Re: Acme Ozone- Facade dwgs

Dear Ashwini & Asmita,
Based on our discussion yesterday following are the points:
3BHK - ok

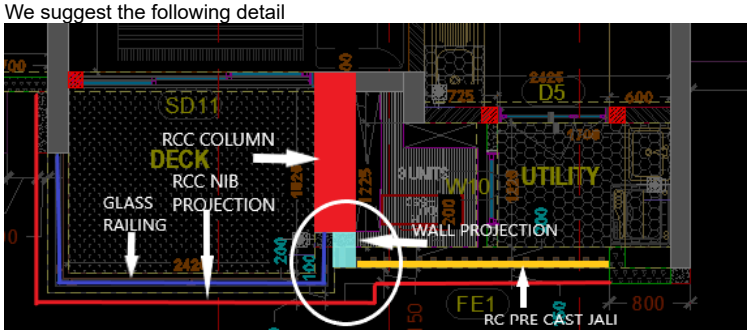
2bhk - 60/65MM gap to be avoided as it will be perceived as work to be completed scenario.
We suggest the following detail

Please review the same.
